ADDENDUM #1

TO CONTRACT DOCUMENTS FOR: Project CP231262 – Schweitzer Hall Roof Replacement

CONSULTANT: RMT Roofing & Waterproofing Consultants
Attn: Ryan O’Connell
410 Sovereign Court, Suite 18
Manchester, MO 63011
(636) 391-2185

DDC PANEL MOUNTING DETAIL
NO SCALE

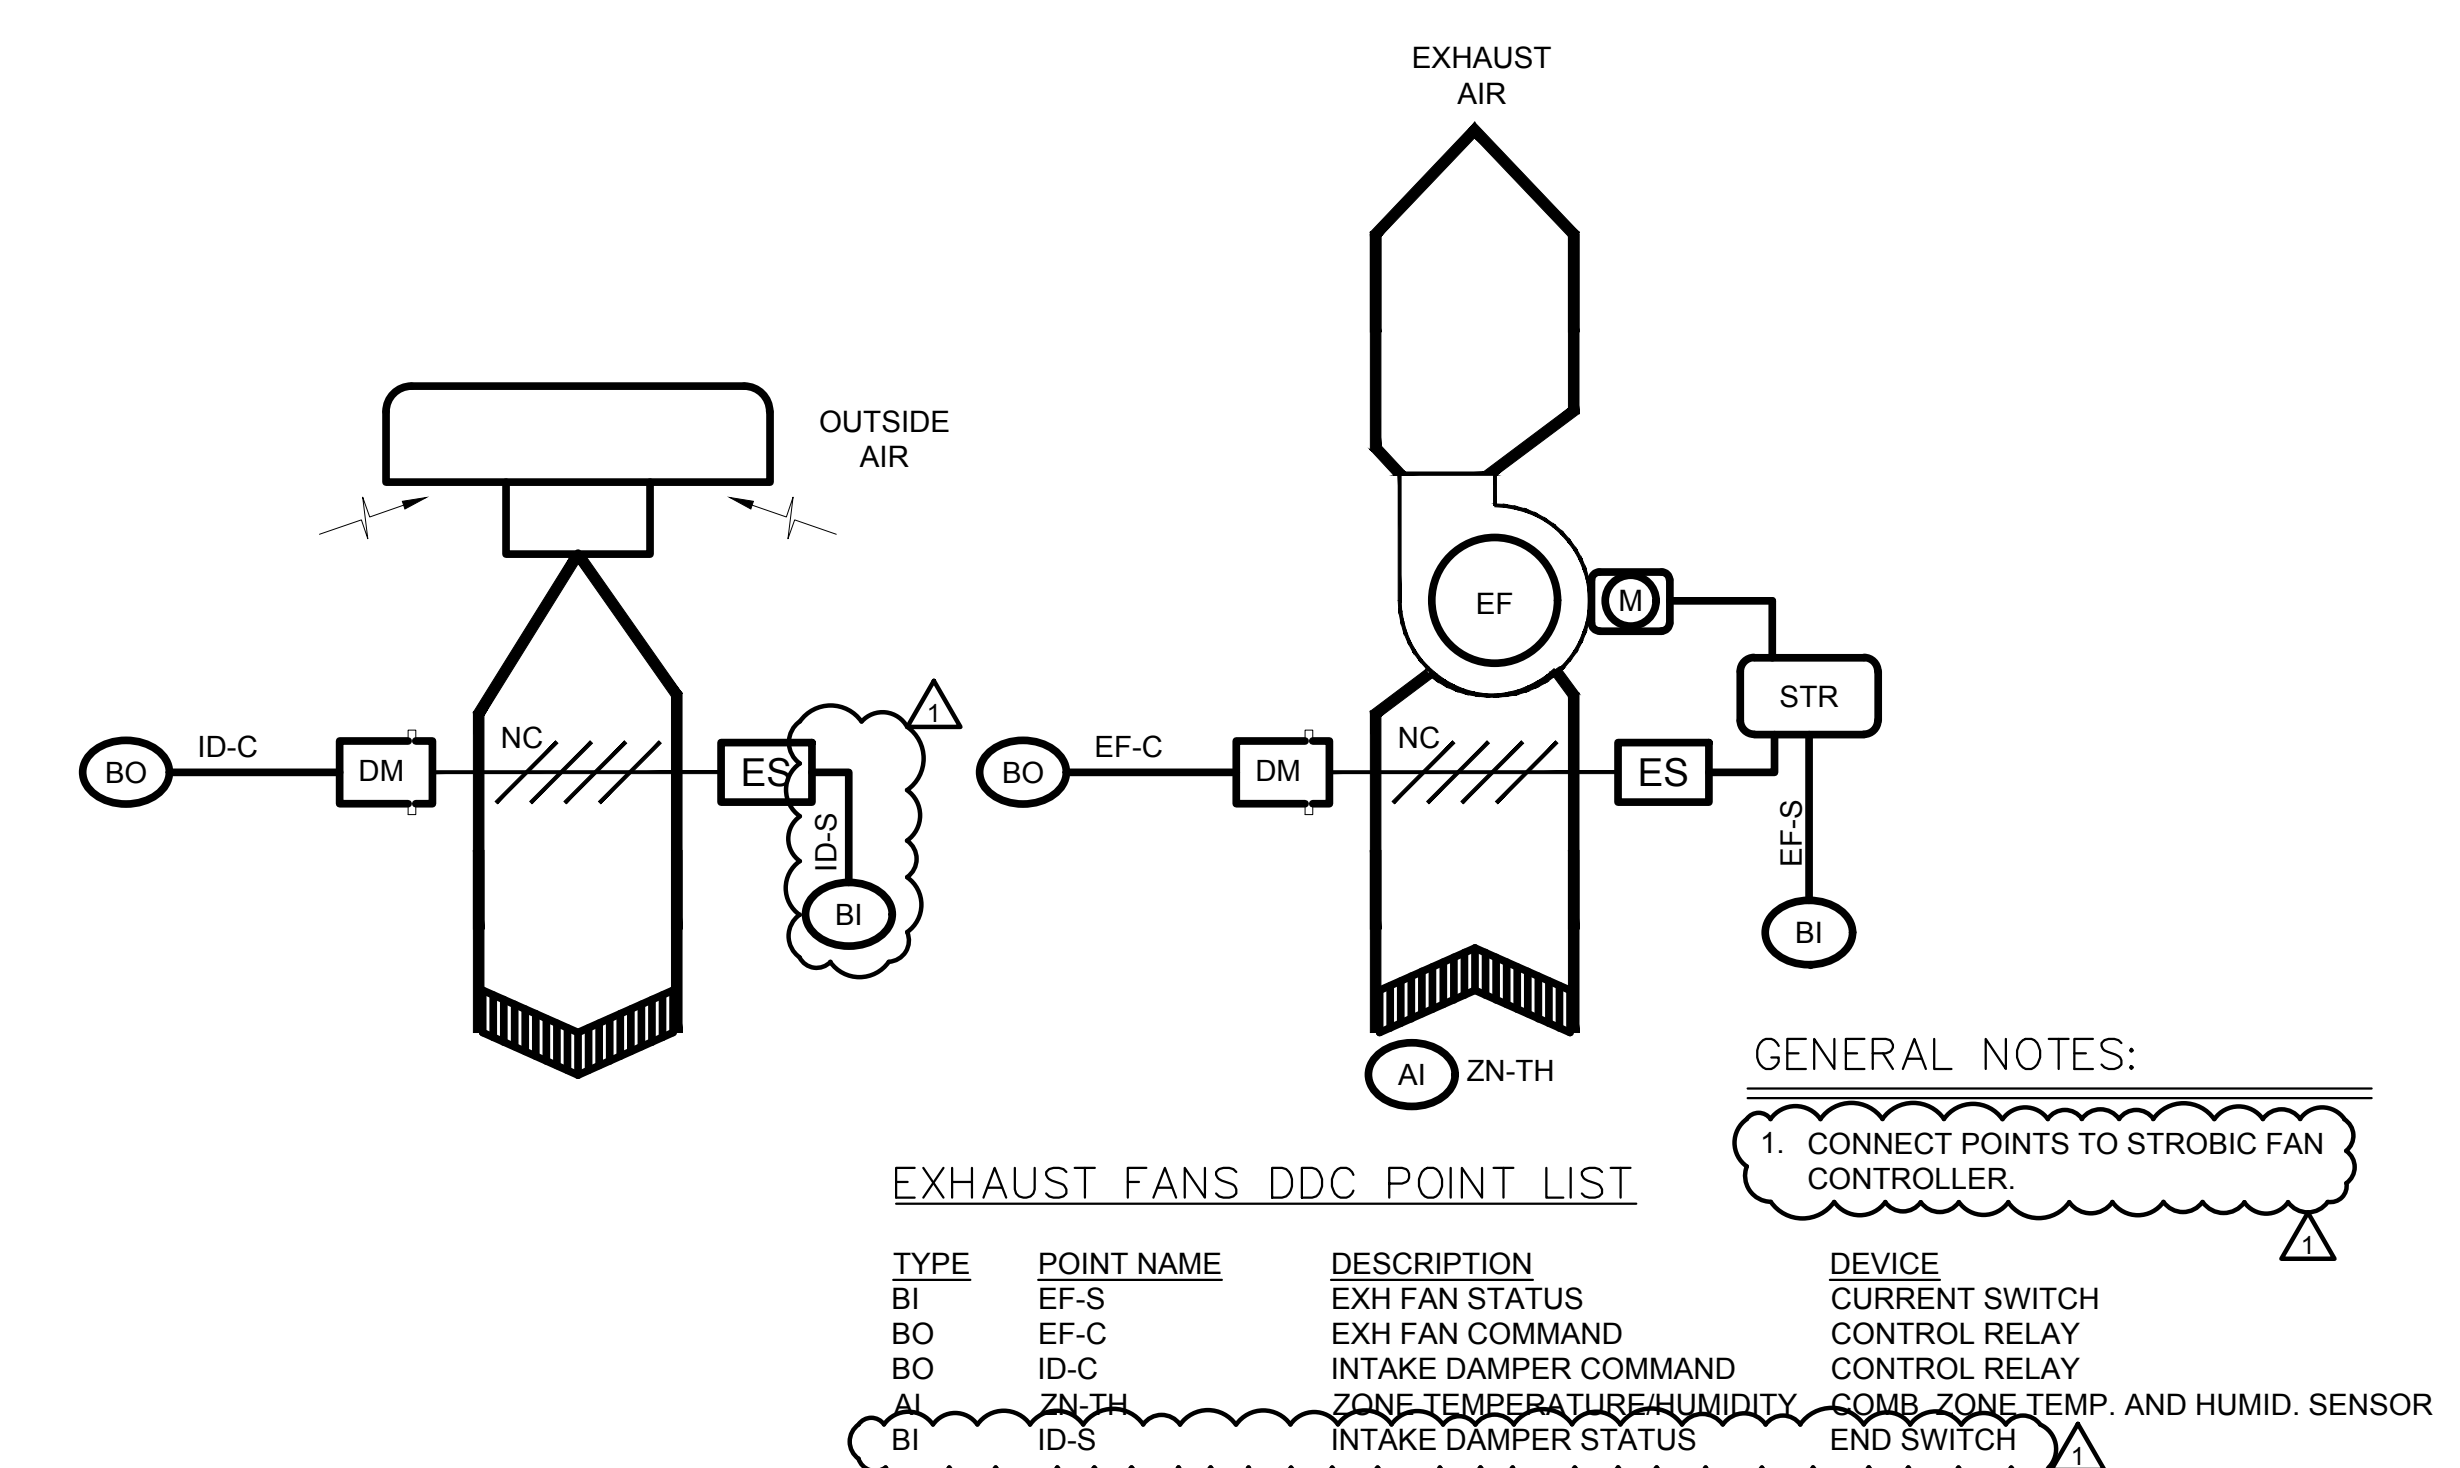
- 1) M5.01 – **ADD** – DDC Panel Mounting Detail
- 2) M5.01 – **REVISE** – Strobic Exhaust Fan Detail
- 3) M5.01 – **REVISE** – Exhaust Fan Control Detail
- 4) M5.01 – **REVISE** – FC BUS Schematic Diagram
- 5) M5.02 – **DELETE** – Lab Exhaust Fan Start Circuit
- 6) Scaffolding shall be erected at the north end of the building to help protect vehicles.
